VILLAGE PLAN COMMISSION AGENDA

Village of Kimberly Request for Plan Commission Recommendation

ITEM DESCRIPTION: Planned Unit Development Amendment – Lot 27 of Rivers Edge Subdivision

Proposed Development: Rivers Edge Lot 27

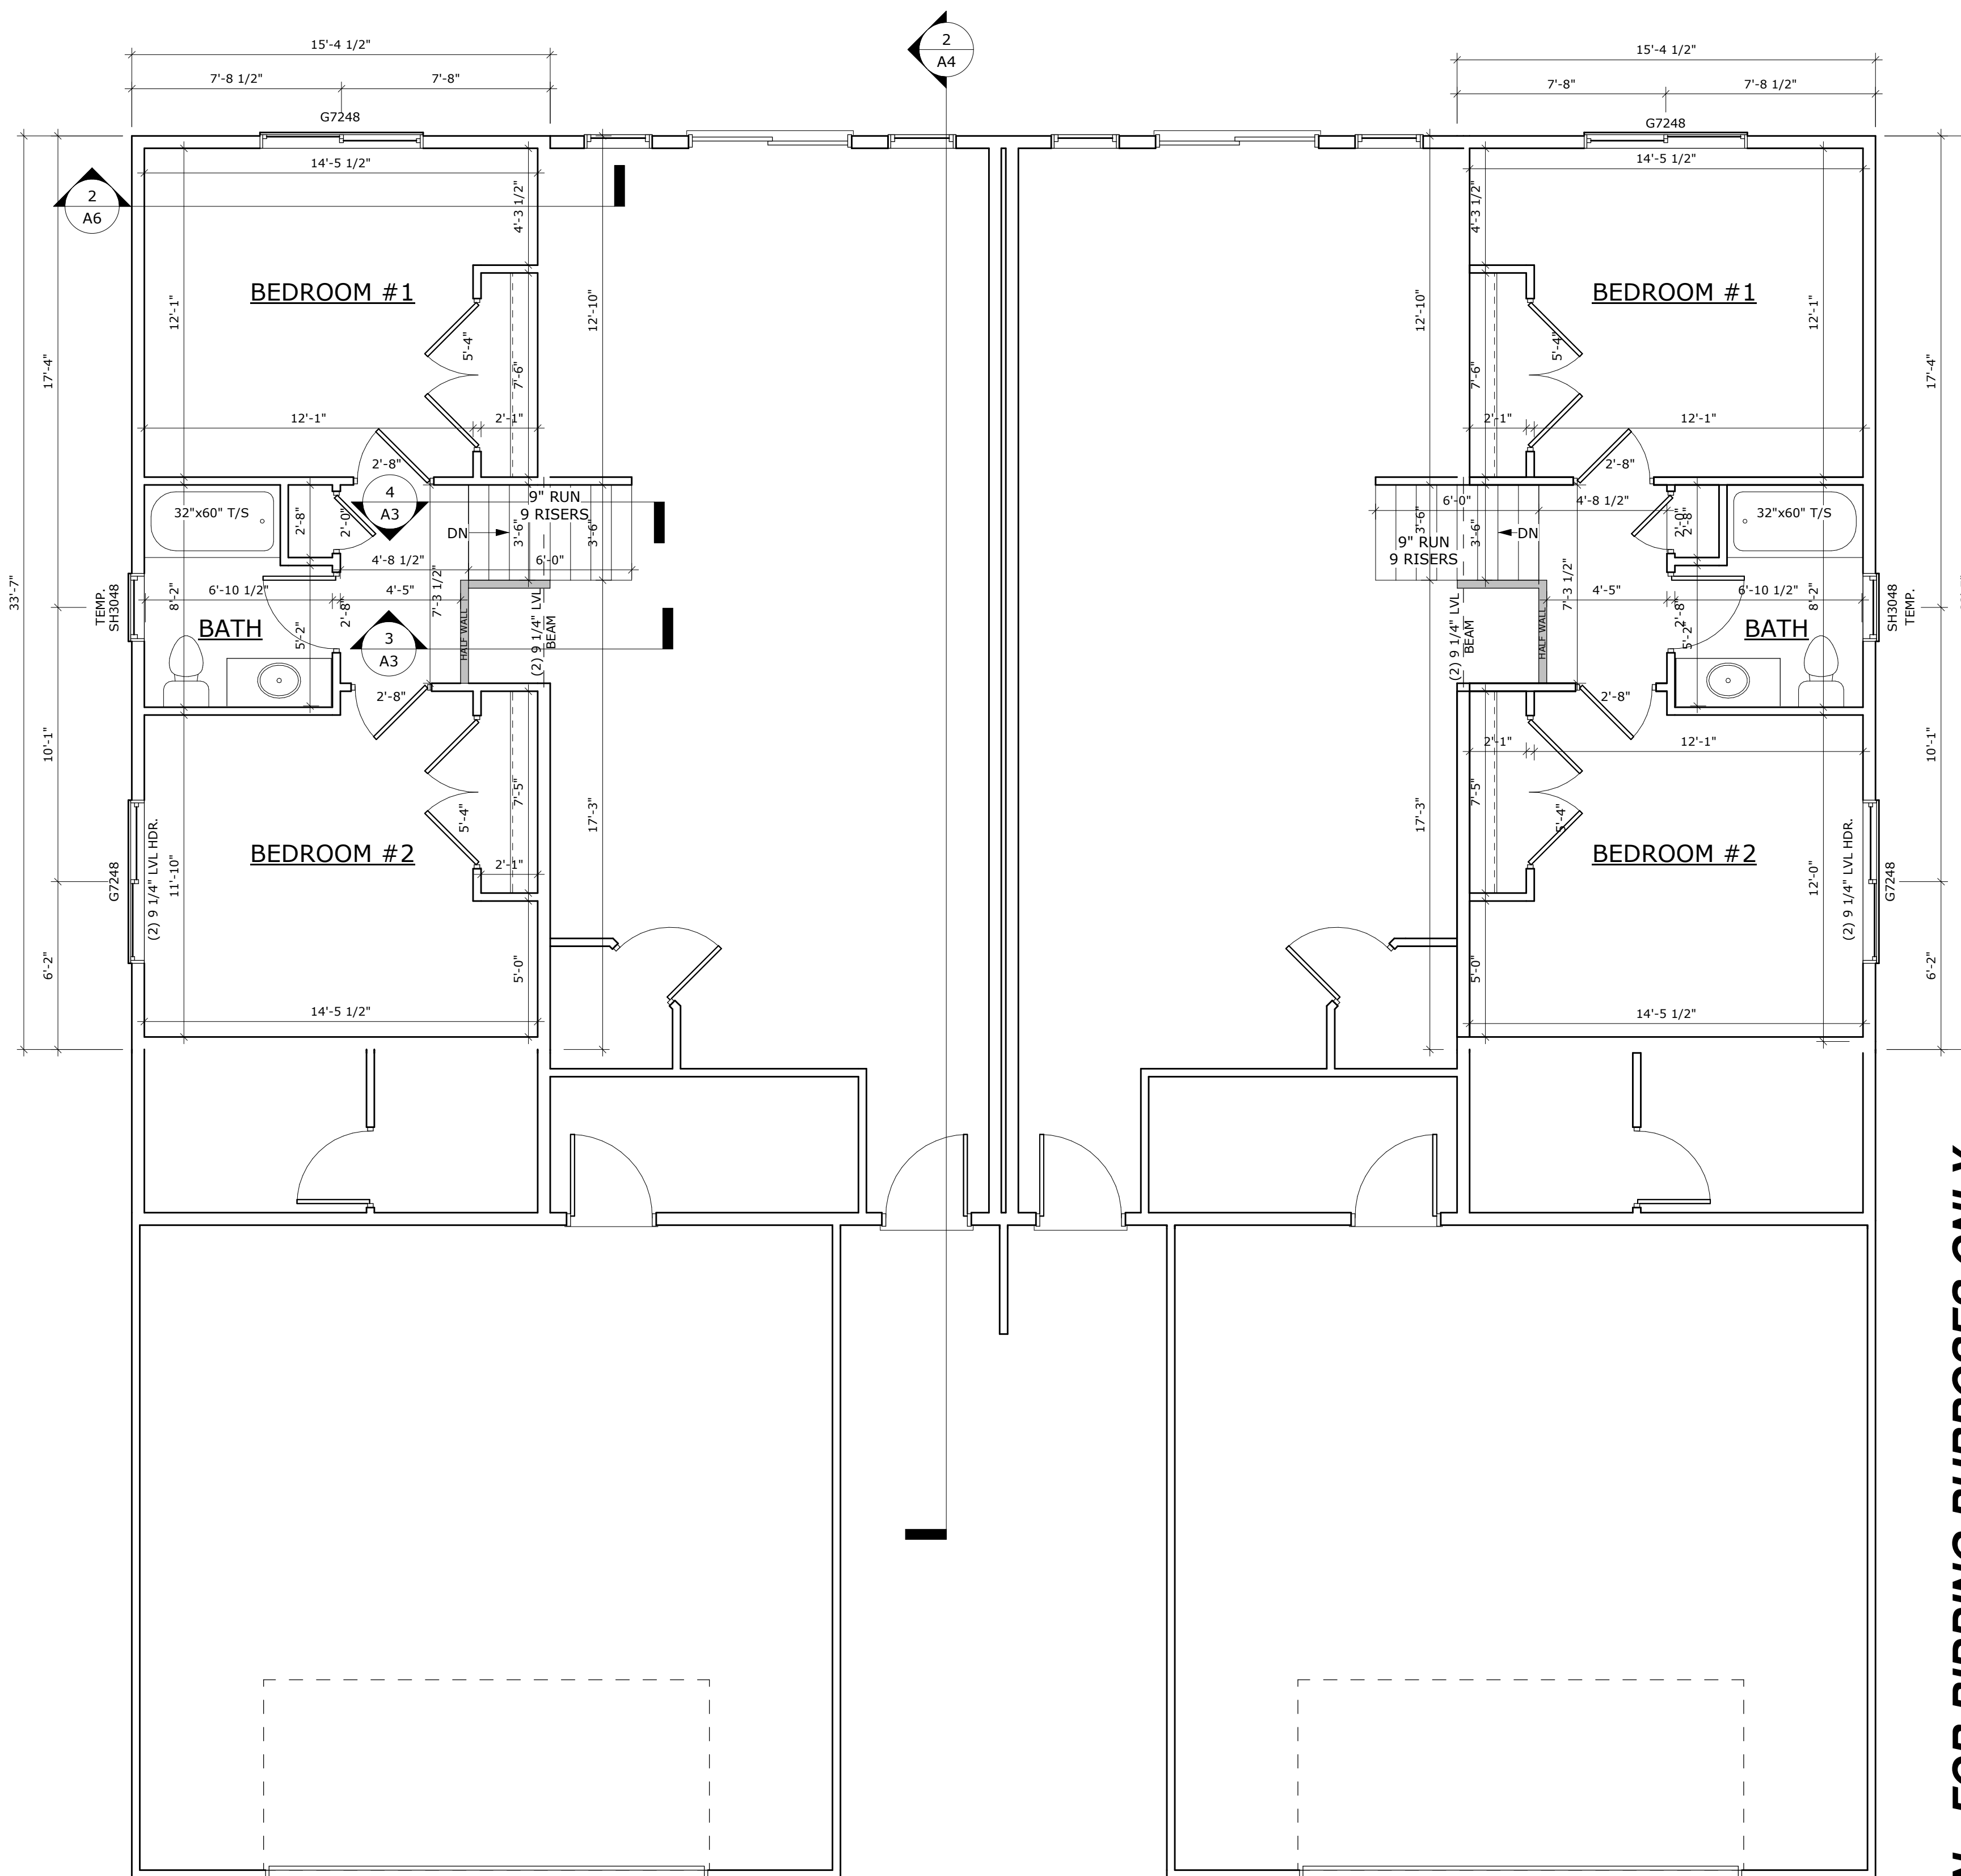
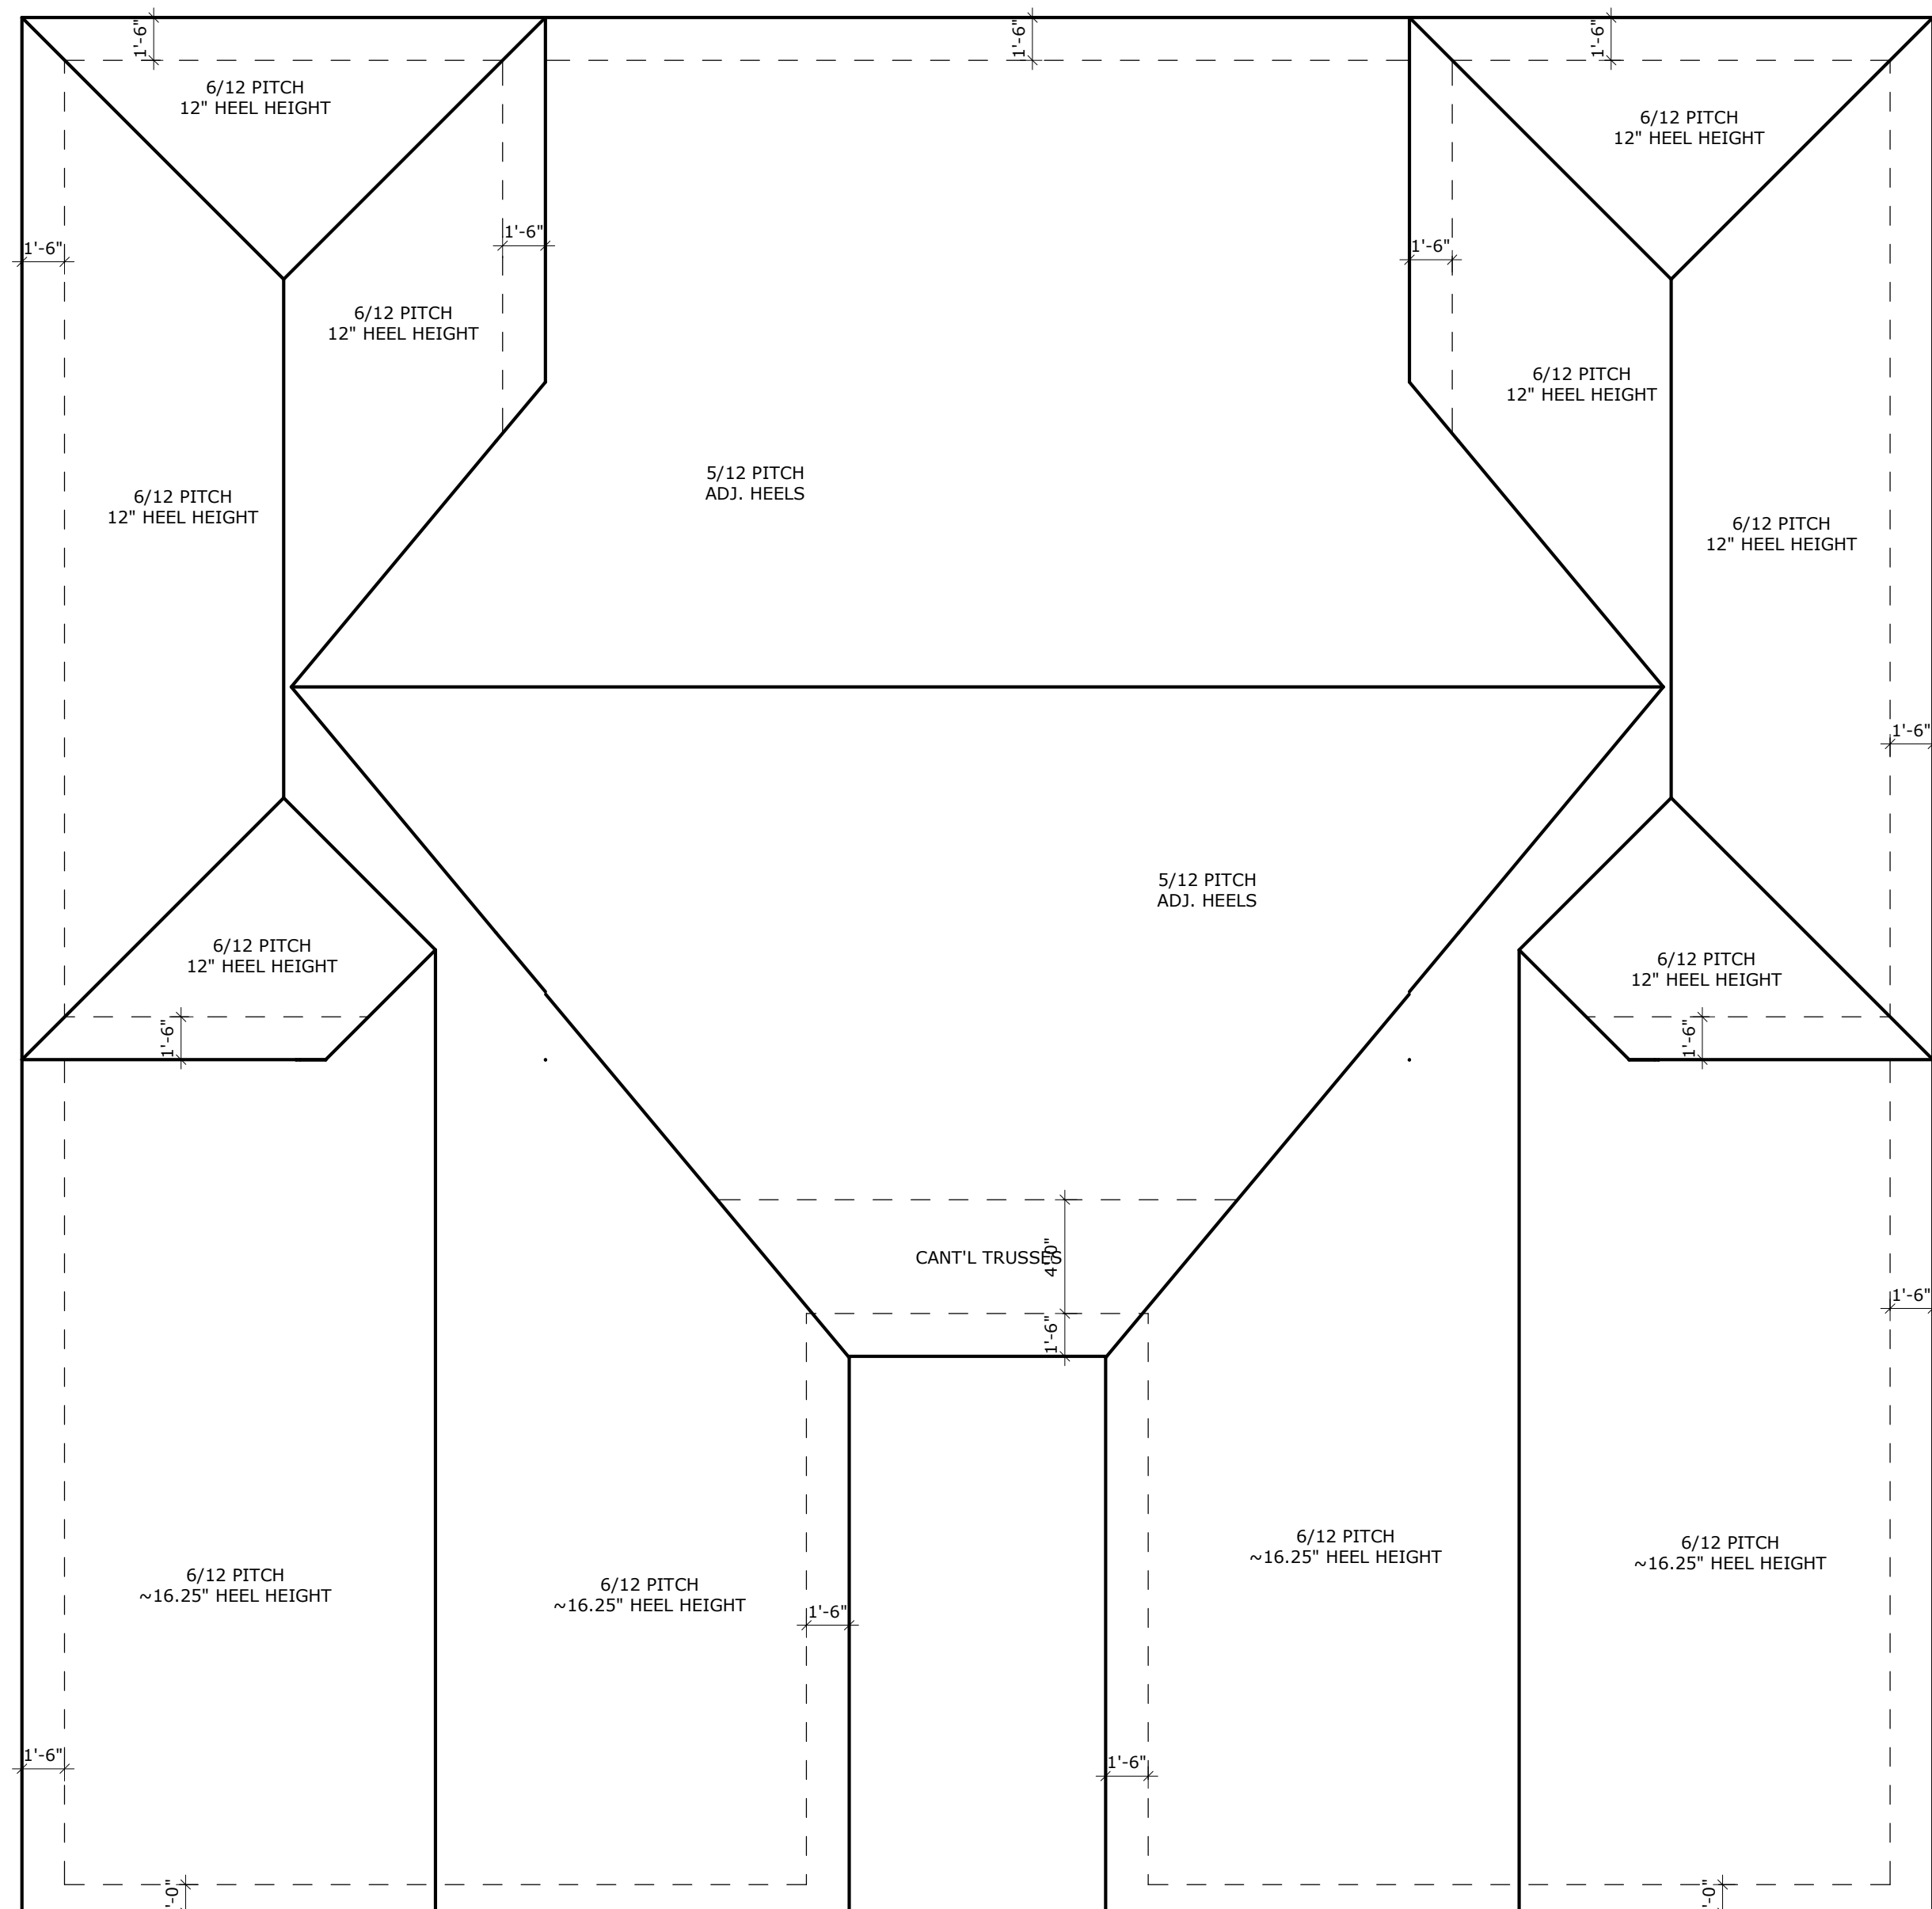
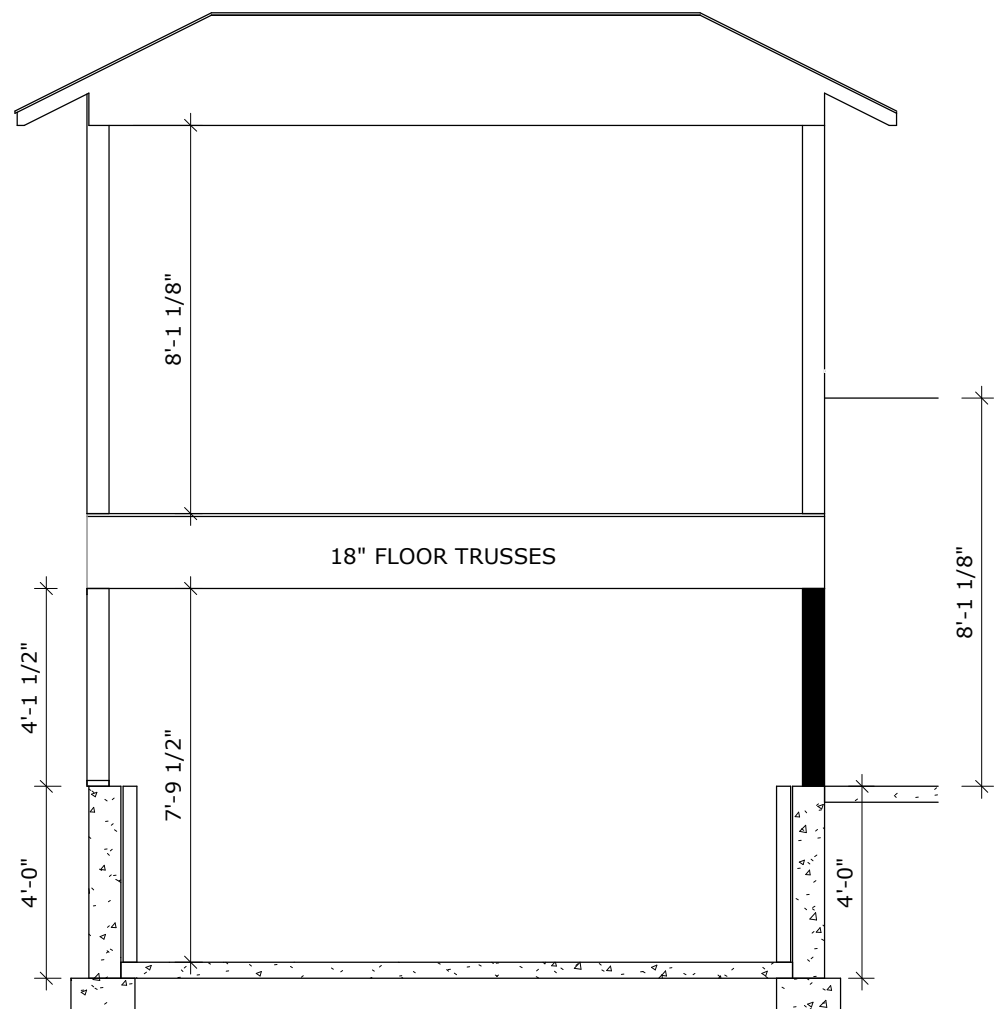
1. Additional architectural elements such as stone, brick, board and batten or shake shall be added to the building in both the front and rear facades of the dwellings to better fit with the surrounding development.
2. Minor modifications to the principal building shall be permitted upon review by the Village staff.
3. The principal building shall be setback a minimum of 25 feet from the adjacent properties.
